**Re: Expert witness evidence errata**

During preparation for the IAC Hearing, I have uncovered three drafting errors in my Expert Witness Statement and Expert Witness Statement Addendum as described below.

**Figure 1: Mitchell River flow duration curve at Glenaladale (gauge site 224203)**

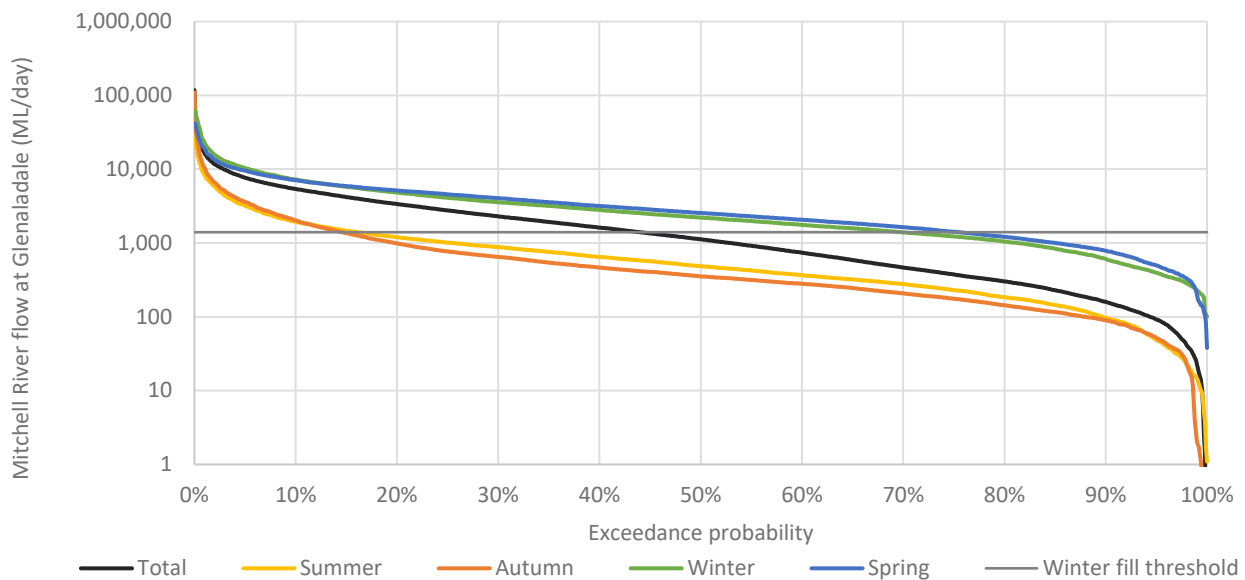
Figure 2.1 in these letters presents a flow duration curve for the Mitchell River. This figure is incorrect; the template used to create the figure was not updated to use data for the Mitchell River, and data for a different river is displayed.

The corrected figure is included below as Figure 1.

This error did not affect calculations; the correct streamflow data was included in the model.

Figure 2 Annual transfer rates – Year 5 – Median conditions (black: flow rates; blue: change in storage over the year)

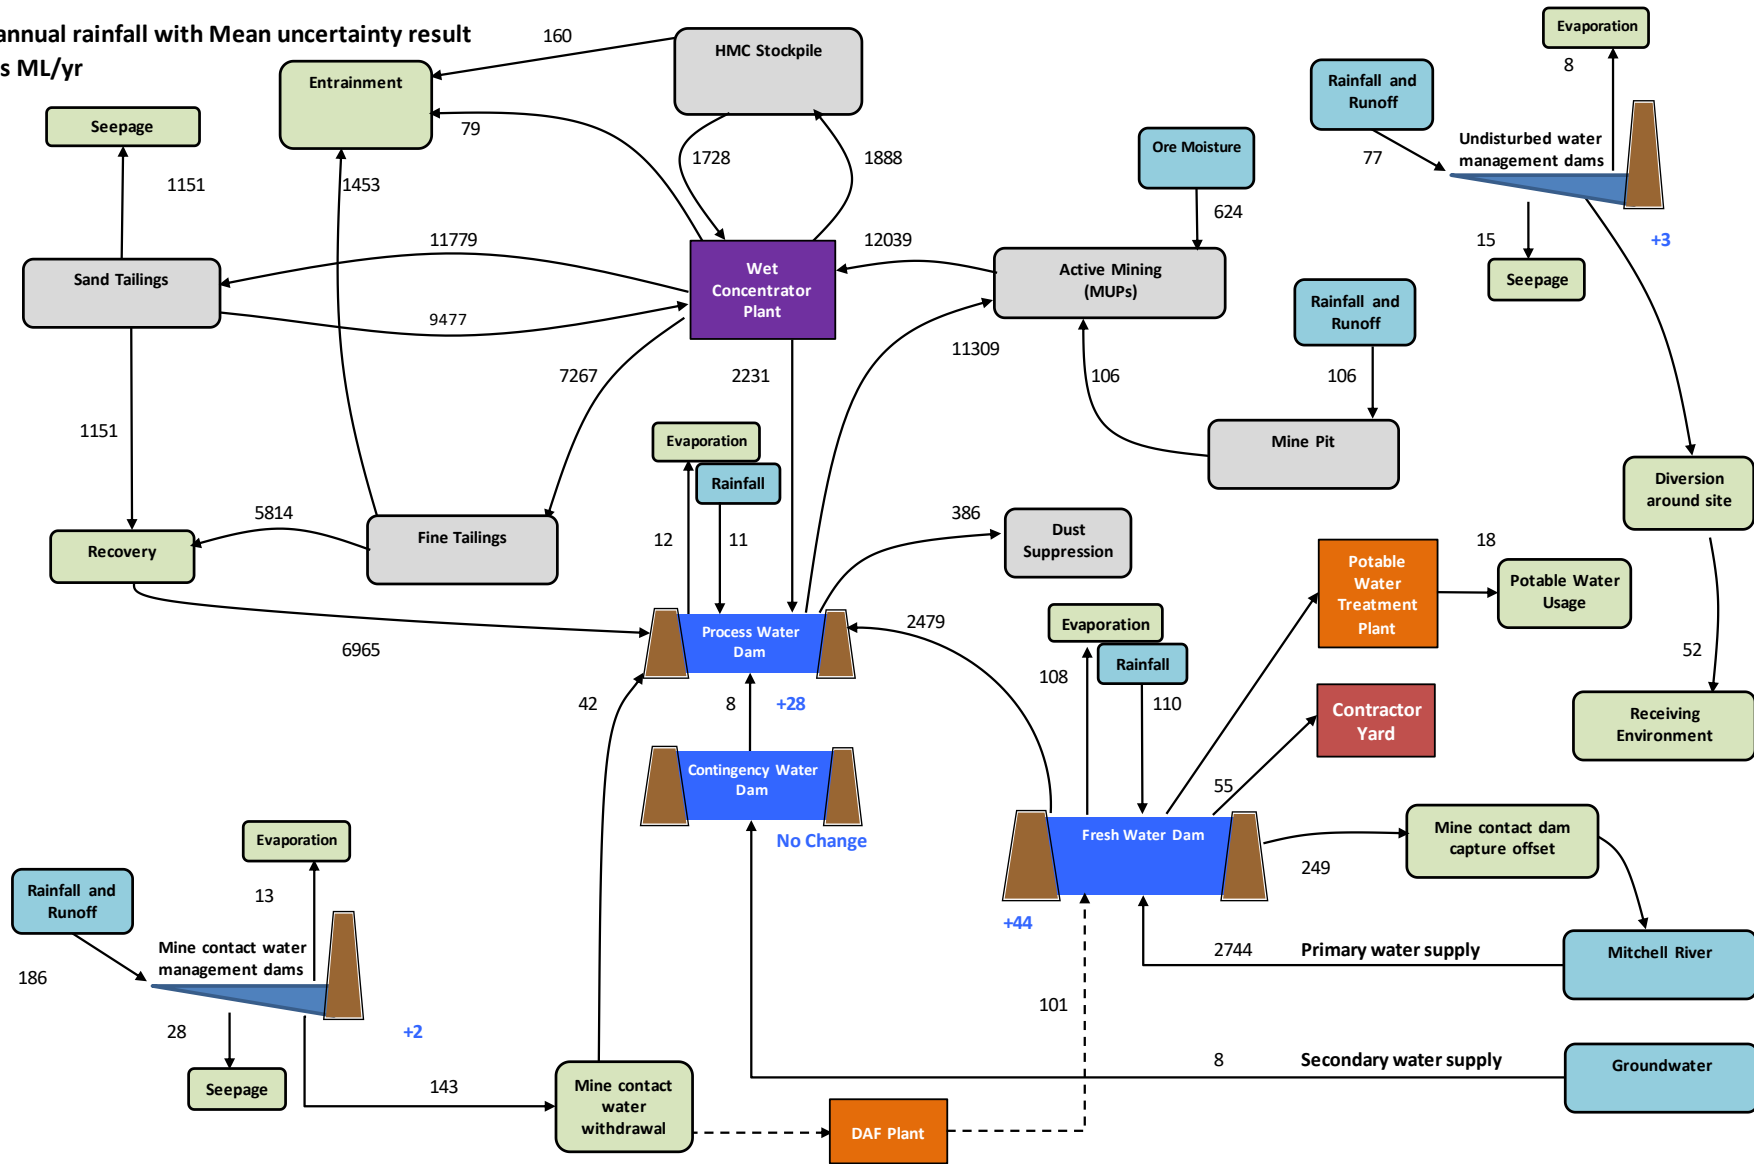
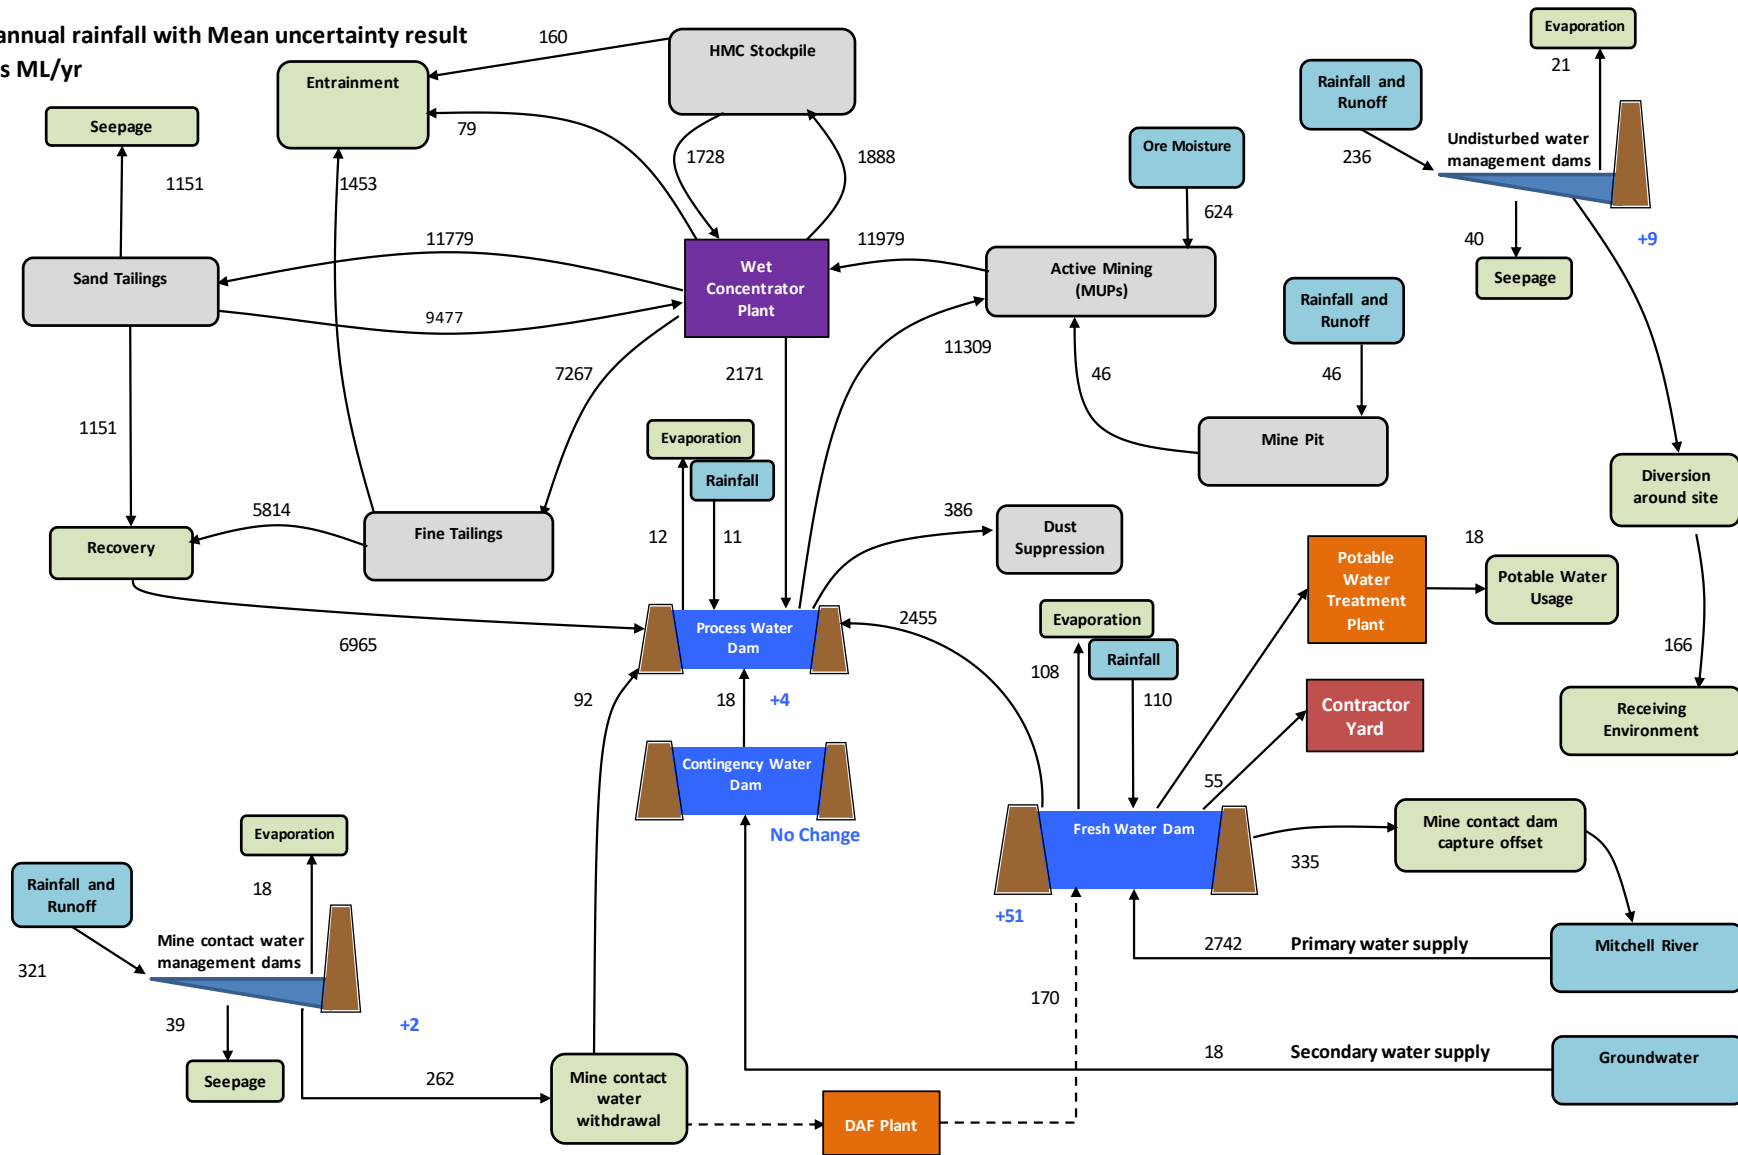
- flow results for year 5, year 8 and year 15 mine layouts in Figures 3.1 to 3.3, describes as results for “Median annual rainfall with Mean uncertainty result”; and
- a summary of water volumes entering and leaving the site in Figure 3.4.

These figures incorrectly display water balance results for 10% percentile rainfall, not median rainfall as described.

Corrected figures are included below.

This error affects the presentation of volumes of rainfall runoff to water management dams within these figures only, and does not affect other model results.
